# Changing assigned Class through DLL v101

## Info (not part of baseline)

### 33.3.6 PD classifications

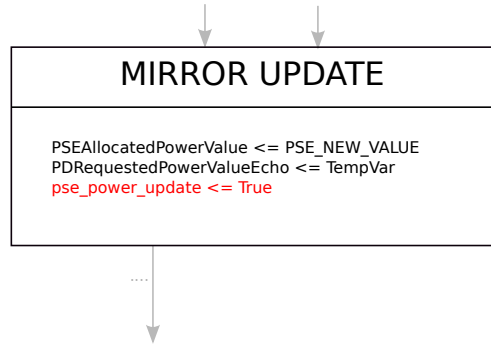
Why to allow it in the text???

After a successful DLL classification, the assigned Class changes depending on the value of PDMaxPowerValue variable, as defined in Table 33–24. A PD may be able to get a Class assigned that is higher than its requested Class, however it is not permitted to draw more power than what corresponds to the PDs requested Class.
